22-COA-0173

927 E. Main Street

Butchertown Architectural Review Committee
Bradley Fister, Planning & Design Coordinator
May 31, 2023

Proposed Design

Third Floor Plan May 18, 2023

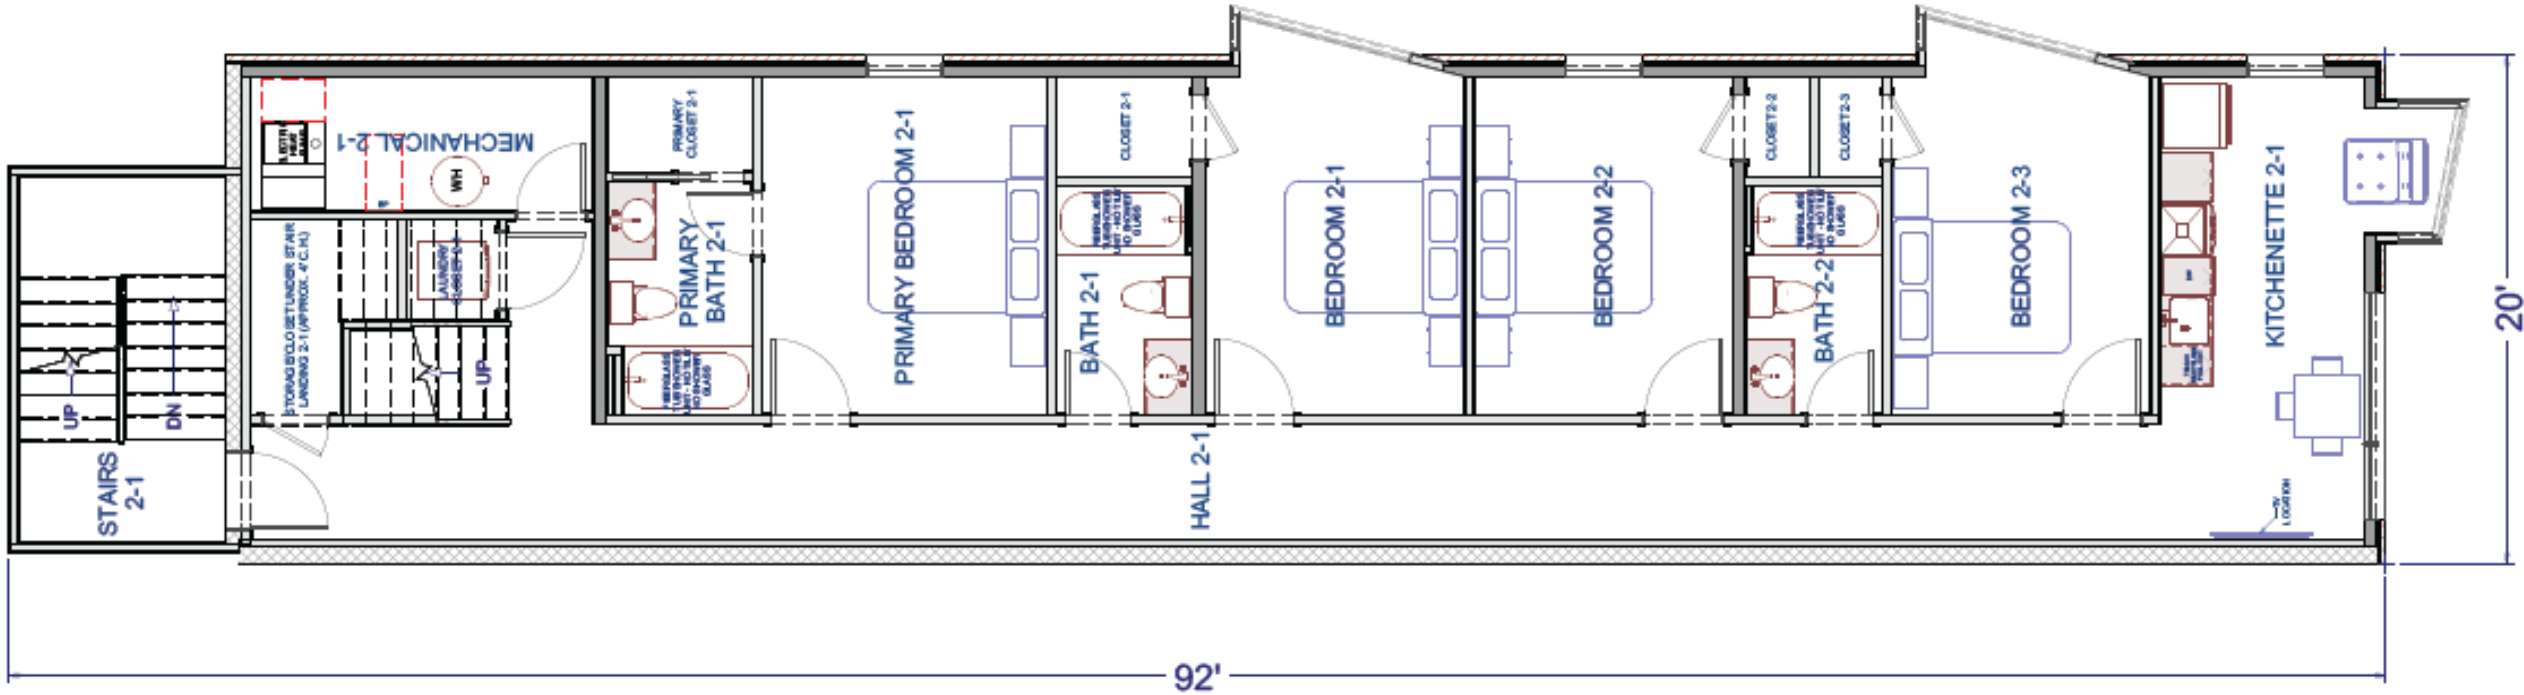
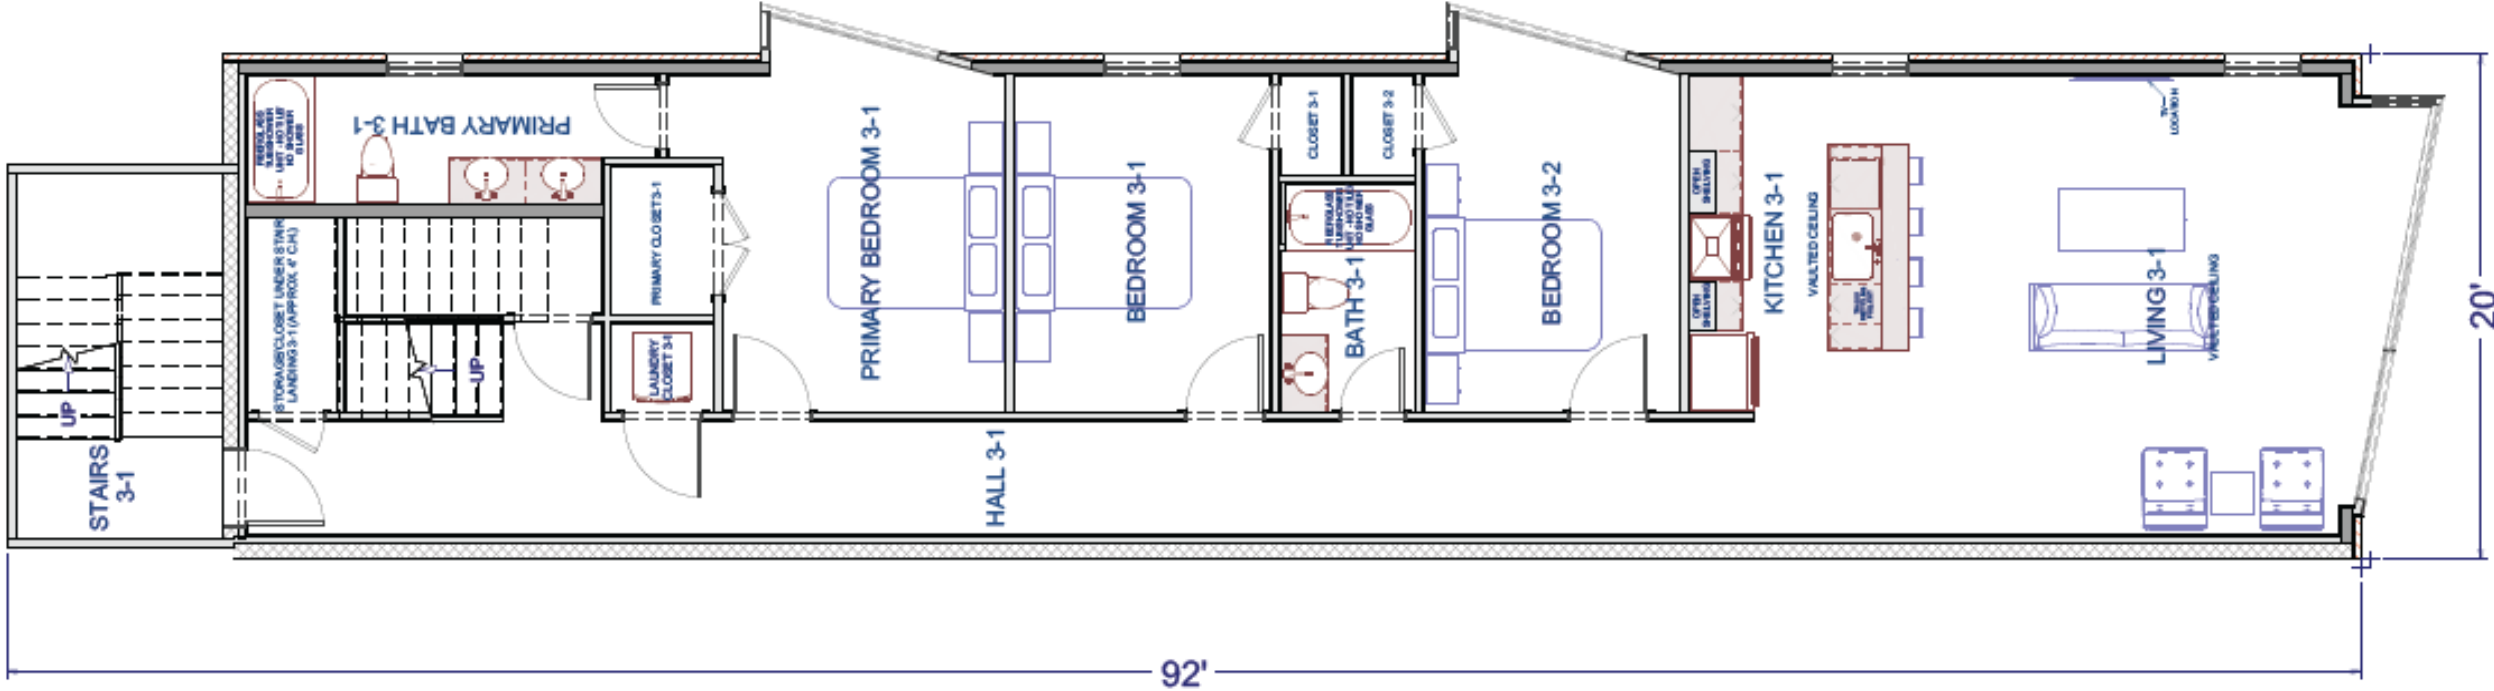
1. The west elevation CMU wall shall be covered with a mural approved by Landmarks staff. The proposed mural should also be reviewed by Metro's Commission on Public Art (COPA).
2. The third story picture windows shall be reduced to a scale similar to the first and second story windows.
3. All window glazing shall be clear.
4. The fiber cement panels on the rear elevation shall be treated in a way that breaks up the massing. That can be further architectural detail, paint, etc.
